A NEW MEDICAL MARIJUANA DISPENSARY INTERIOR TENANT FINISH FOR:

GRD KIRKSVILLE, LLC  
201 SE MO-291  
LEE'S SUMMIT, MISSOURI 64063

- G-000 COVER SHEET  
G-001 STATE AND LOCAL REGULATIONS  
G-002 BUILDING CODE SUMMARY  
G-003 RESPONSIBILITY MATRIX
- A-100 FLOOR PLAN & DETAILS  
A-200 INTERIOR WALL SECTIONS  
A-300 SCHEDULES  
A-400 CEILING FRAMING, REFLECTED CEILING PLAN

RESPONSE TO PLAN REVIEW COMMENTS (5/23/2022)

BUILDING  
CODE  
SUMMARY

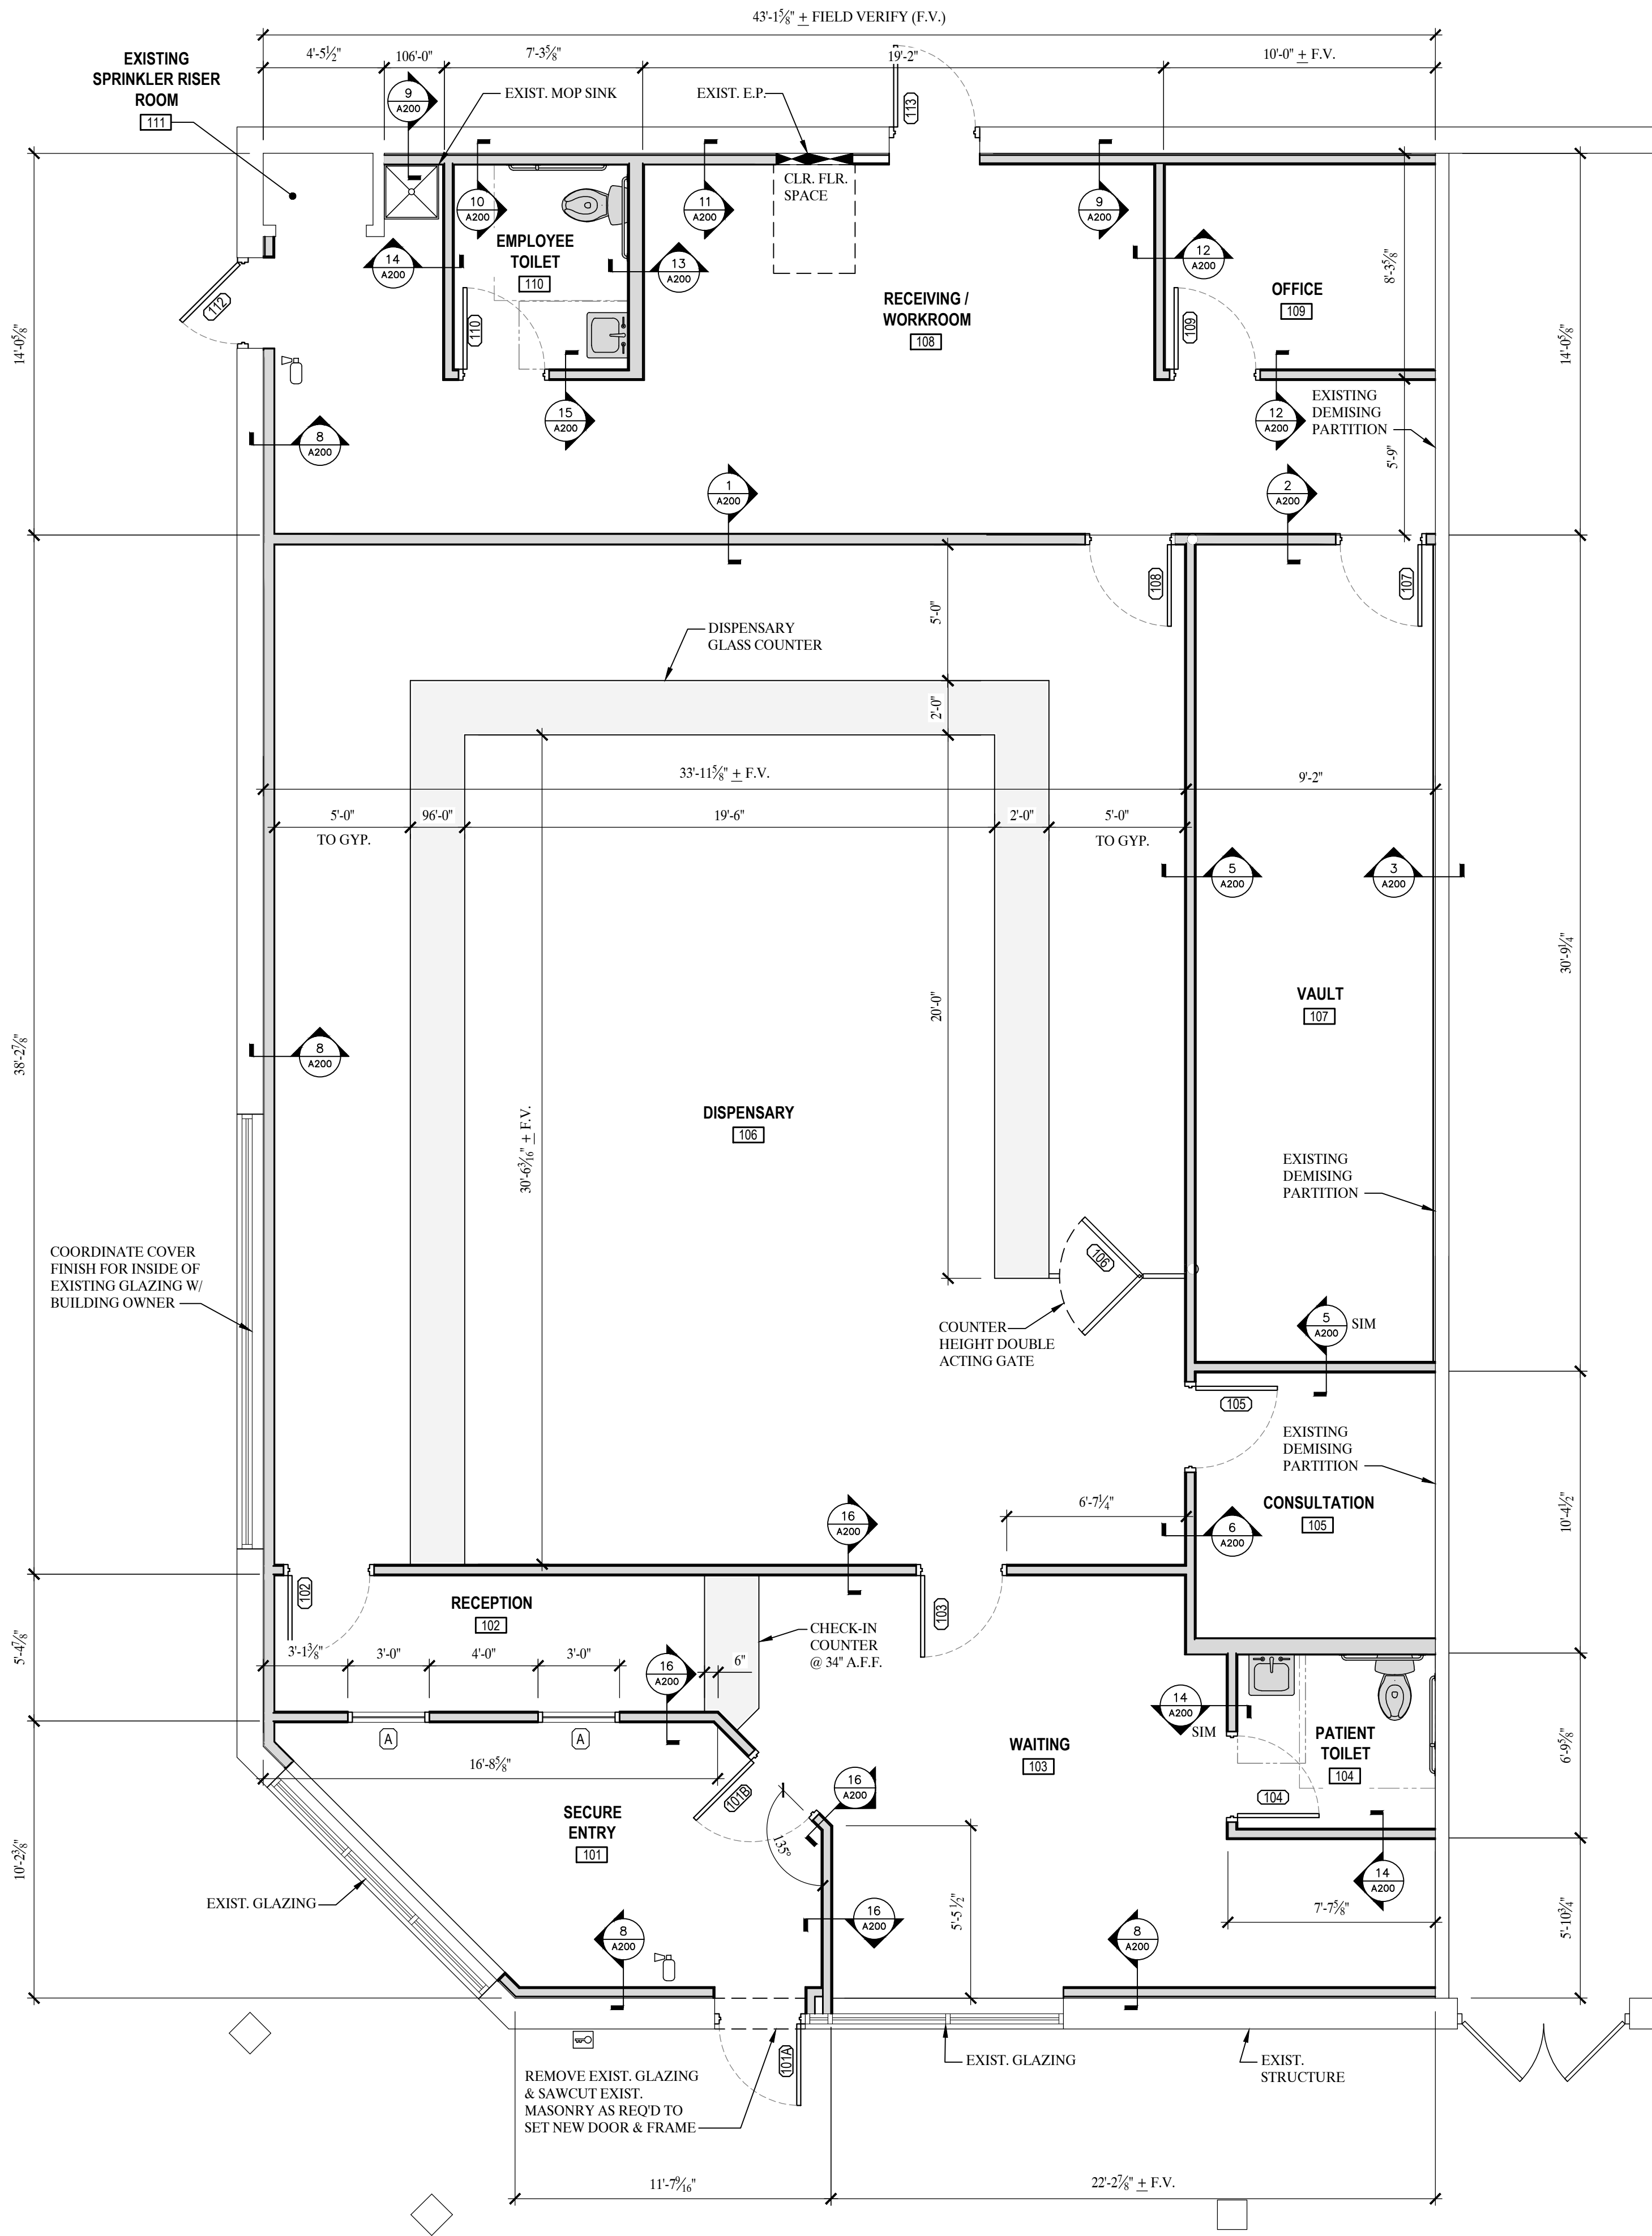
RESPONSE TO PLAN REVIEW COMMENTS (5/23/2022)

- PATIENT TOILET 104 IS MODIFIED TO PROVIDE THE MINIMUM 18" CLEARANCE AT LATCH SIDE OF DOOR.
- A BOTTLED WATER APPLIANCE SHALL BE PROVIDED.
- EPOXY BASED PAINT SHALL BE USED AS WALL FINISHES WITHIN TOILET ROOMS AND MOP SINK AREA, AS REQUIRED.

- THE EXISTING 5-TON ROOF TOP UNIT IS BEING REPLACED WITH A NEW 5-TON ROOF TOP UNIT. WEIGHTS ARE SIMILAR.
- THE GENERAL CONTRACTOR'S FIRE ALARM CONTRACTOR SHALL SUBMIT REQUIRED FIRE ALARM CONSTRUCTION DOCUMENTS FOR REVIEW AND APPROVAL, PRIOR TO INSTALLATION.

- THE BACK EXTERIOR DOOR AND INTERIOR DOOR SHALL BE MARKED SPRINKLER ROOM AND SPRINKLER ROOM ACCESS, AS REQUIRED.
- THE GENERAL CONTRACTOR'S LICENSED SPRINKLER CONTRACTOR SHALL SUBMIT REQUIRED SPRINKLER MODIFICATION CONSTRUCTION DOCUMENTS FOR REVIEW AND APPROVAL, PRIOR TO INSTALLATION, AS REQUIRED.

- ALL DOOR HARDWARE IS UNLOCKED FROM THE EGRESS SIDE, AS REQUIRED.
- A KNOX BOX SHALL BE PROVIDED WITH LABELED ACCESS KEYS, AS REQUIRED.

TITLE :  
**HVAC PLAN**

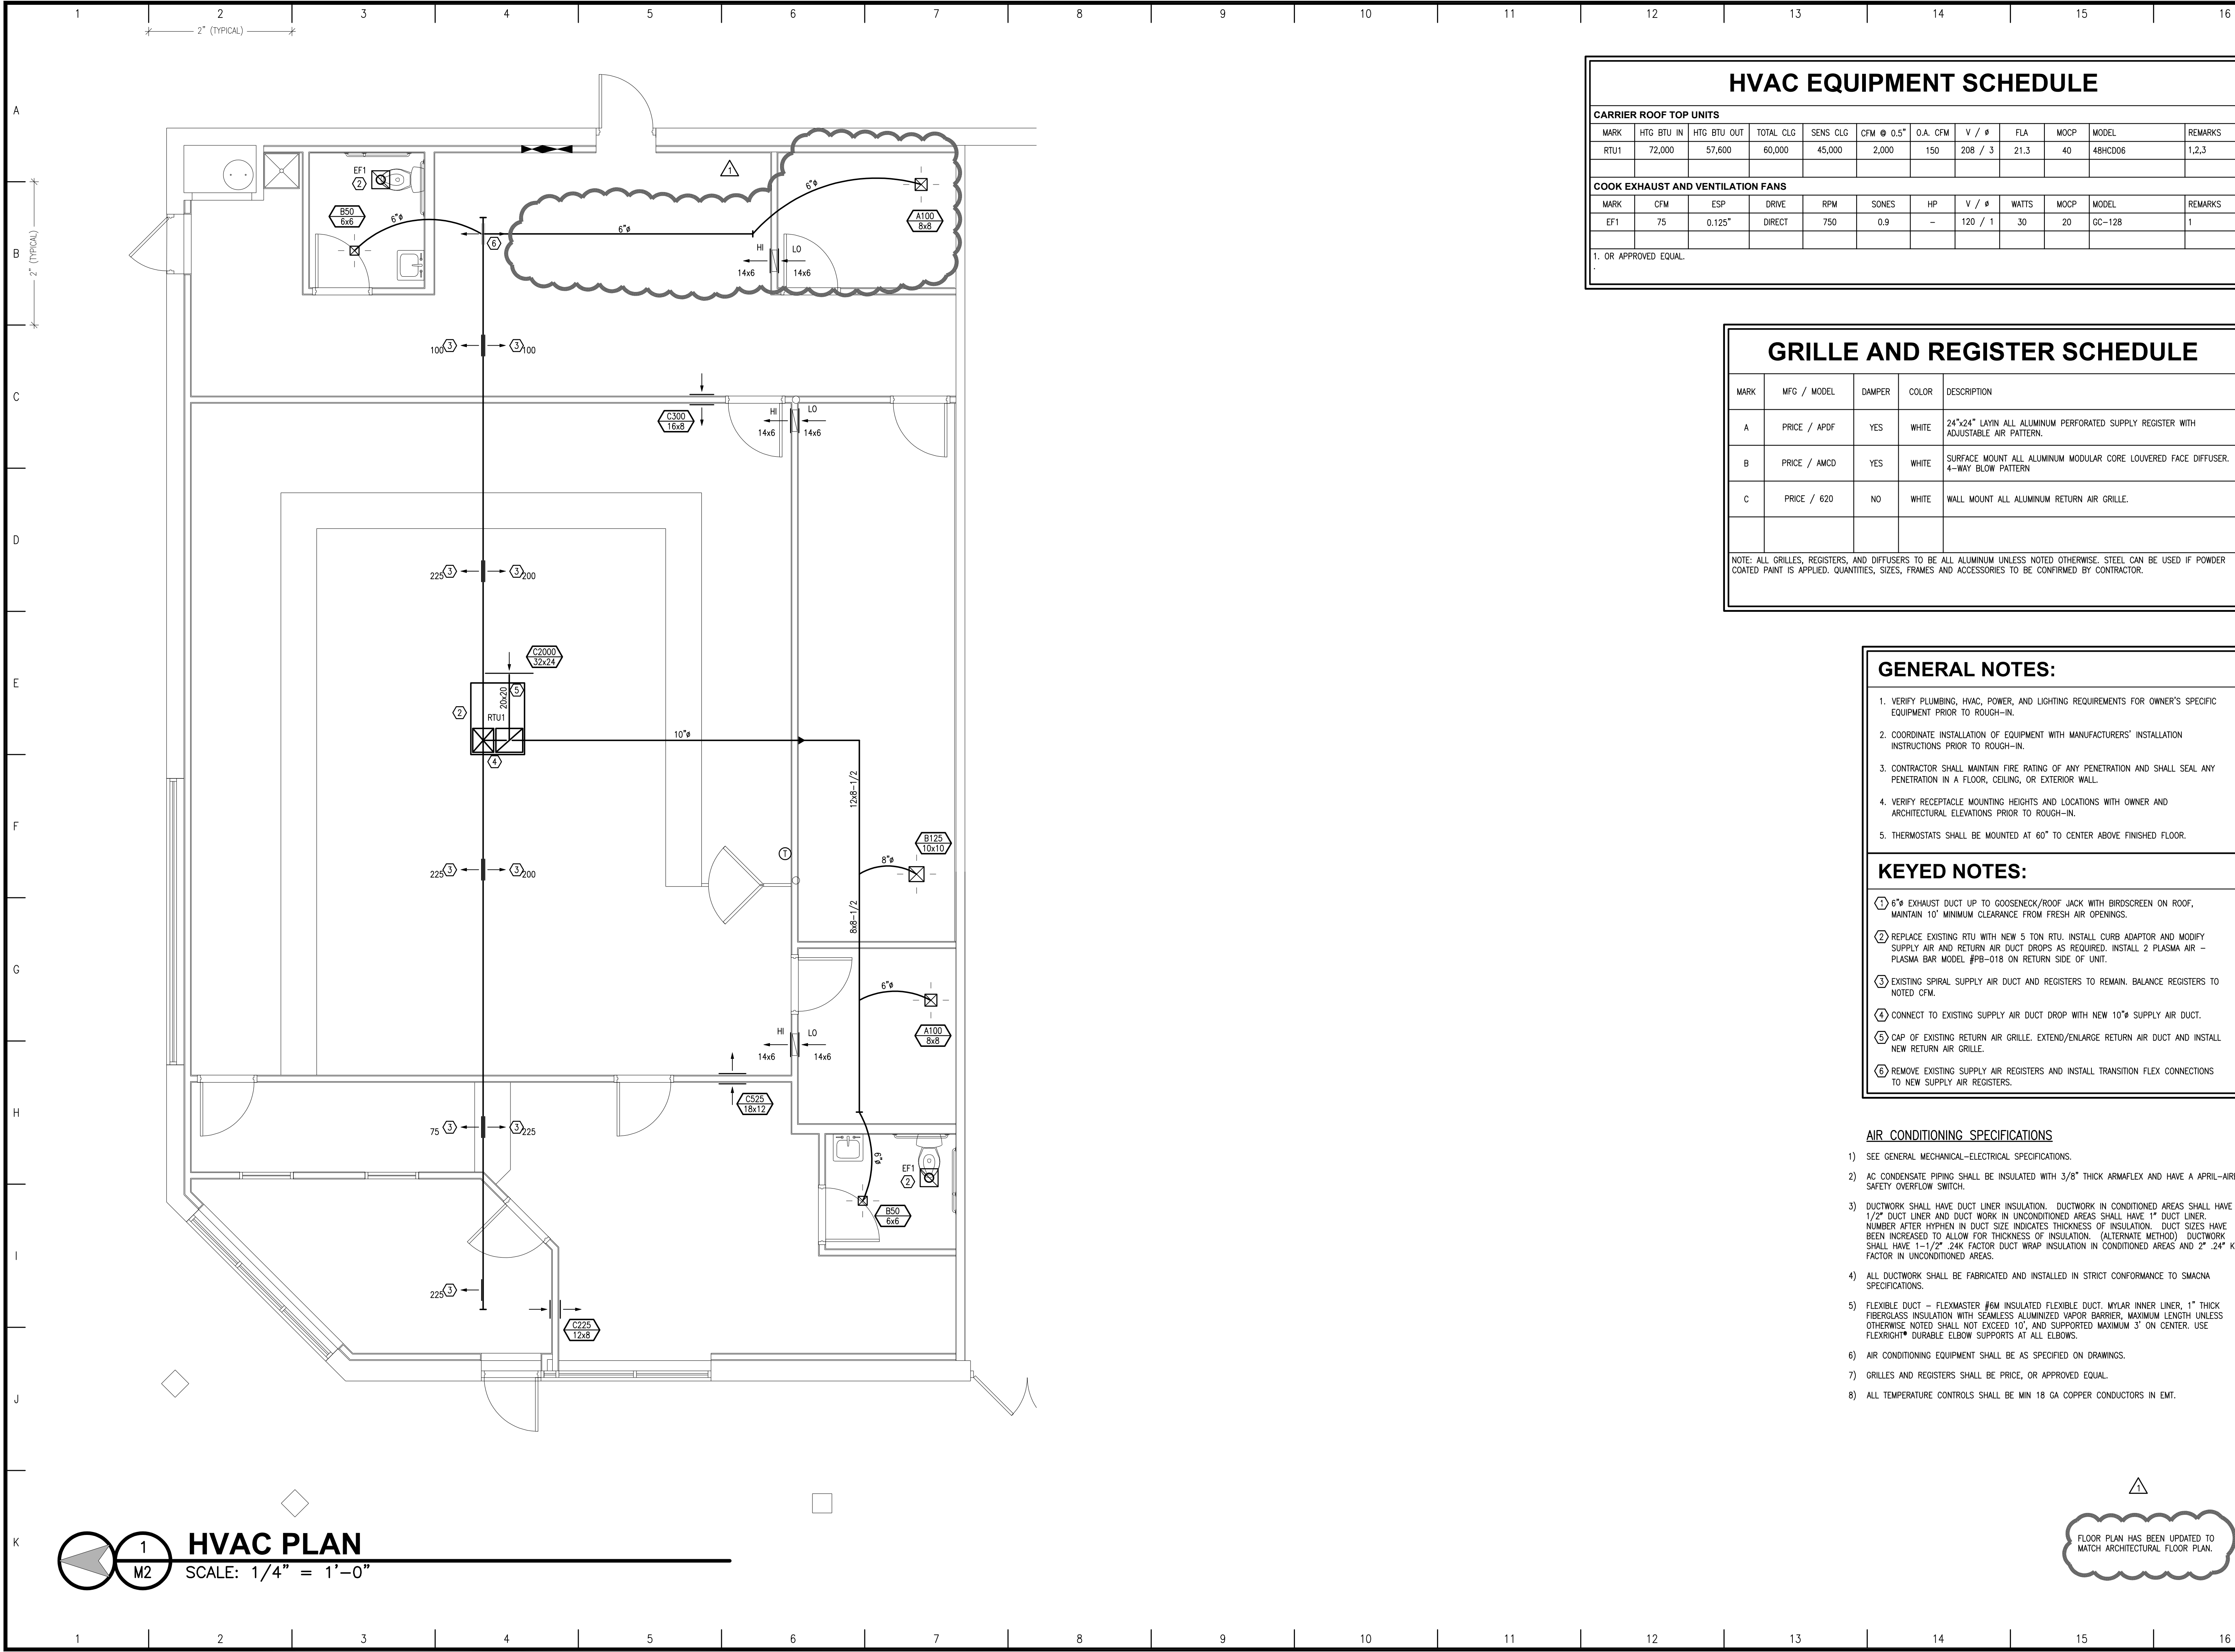
- ① 6" EXHAUST DUCT UP TO GOOSENECK/ROOF JACK WITH BIRDSCREEN ON ROOF, MAINTAIN 10" MINIMUM CLEARANCE FROM FRESH AIR OPENINGS.
- ② REPLACE EXISTING RTU WITH NEW 5 TON RTU. INSTALL CURB ADAPTOR AND MODIFY SUPPLY AIR AND RETURN AIR DUCT DROPS AS REQUIRED. INSTALL 2 PLASMA AIR - PLASMA BAR MODEL #PB-018 ON RETURN SIDE OF UNIT.
- ③ EXISTING SPIRAL SUPPLY AIR DUCT AND REGISTERS TO REMAIN. BALANCE REGISTERS TO NOTED CFM.
- ④ CONNECT TO EXISTING SUPPLY AIR DUCT DROP WITH NEW 10" SUPPLY AIR DUCT.
- ⑤ CAP OF EXISTING RETURN AIR GRILLE. EXTEND/ENLARGE RETURN AIR DUCT AND INSTALL NEW RETURN AIR GRILLE.
- ⑥ REMOVE EXISTING SUPPLY AIR REGISTERS AND INSTALL TRANSITION FLEX CONNECTIONS TO NEW SUPPLY AIR REGISTERS.

FLOOR PLAN HAS BEEN UPDATED TO MATCH ARCHITECTURAL FLOOR PLAN.
